Subject: Issuance of Amendment No. 9 to Facility Operating License
NPF-9 - McGuire Nuclear Station, Unit 1

MCGUIRE NUCLEAR STATION, UNIT 1

AMENDMENT TO FACILITY OPERATING LICENSE

Amendment No. 9
License No. NPF-9

FIGURE 3.2.3 RCS TOTAL FLOWRATE VERSUS R_1 AND R_2 —FOUR LOOPS IN OPERATION

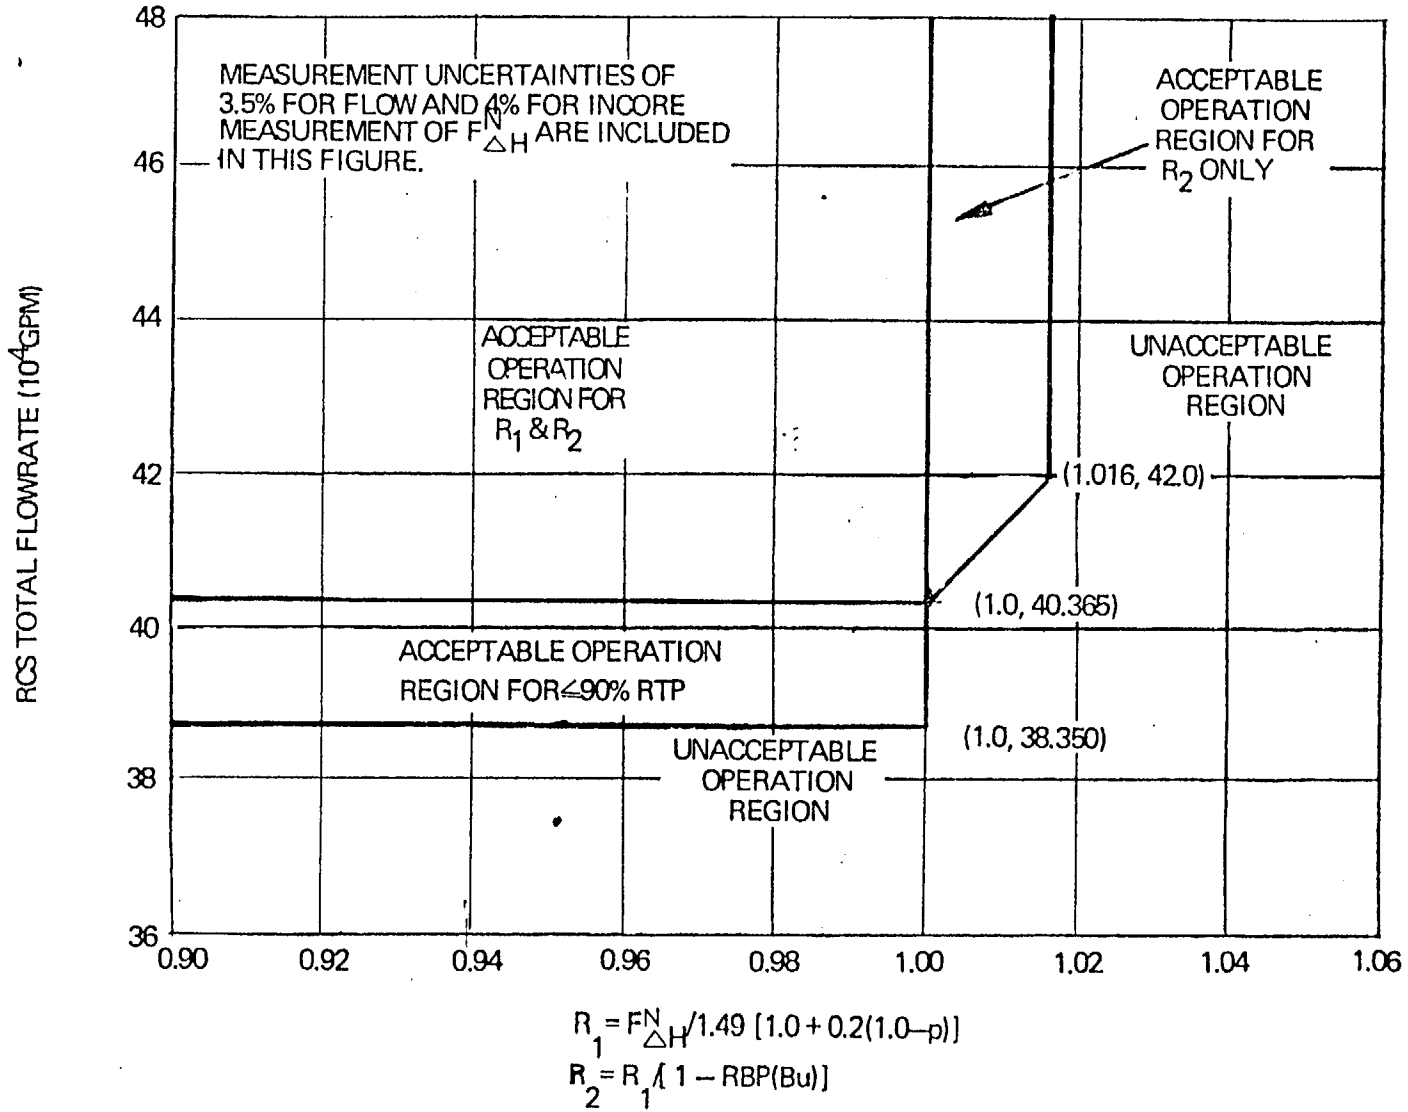
This amendment is in response to your letter dated November 11, 1981. This amendment revises the minimum reactor coolant system flow rate to permit an option for operation at a reduced flow rate (95%) in conjunction with a reduced power level (90%). The amendment is effective as of its date of issuance.

By letter dated November 11, 1981, the licensee requested a change to the McGuire Nuclear Station Unit 1 Technical Specifications, Appendix A, to License NPF-9, Item 3/4.2.3. The requested change relates to the minimum measured reactor coolant system flow rate. Based on preliminary measurements the licensee may be unable to achieve the thermal design flow limits defined in Item 3/4.2.3. The licensee requested that the Technical Specifications minimum reactor coolant system flow rate as a function of F be modified to permit an option for operation at a reduced flow rate (95% of the current value) in conjunction with a reduced power level (90% of the specification value). The reduced power level is specified to maintain the thermal margin at the full flow value which was the basis for the final design safety analysis.

By using this relationship, a 5% reduction in flow results in a 2.7% reduction in power.

The staff has performed an independent ausit using the sensitivity factors reported in References (1), (2) and (3)*. For the worst cast, Reference (3), a 5% reduction in flow requires a 4.32% reduction in power.

Based on our evaluation we conclude that the proposed change to technical specification 3/4.2.3 is acceptable.
